Purpose: To permit the development of a 29-storey mixed-

Property Address/Description: 350, 370 and 390 Queens Quay West

#### PARTICIPANT STATEMENT OF LAURA COOPER

Applicantsø Advertising Featuring the View from the Harbour

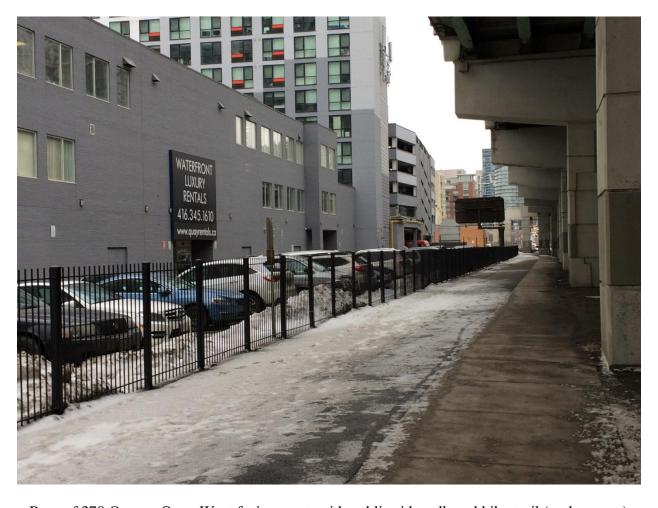
Picture 2 shows how even the Applicant uses a picture of the Rogers Centre taken from H2O west in advertising its business. That is how important things such as iconic buildings are to the industries and commercial enterprises--and ultimately to the way of life of all. Picture 3 shows how even the existing building can impact on the view from the harbour.
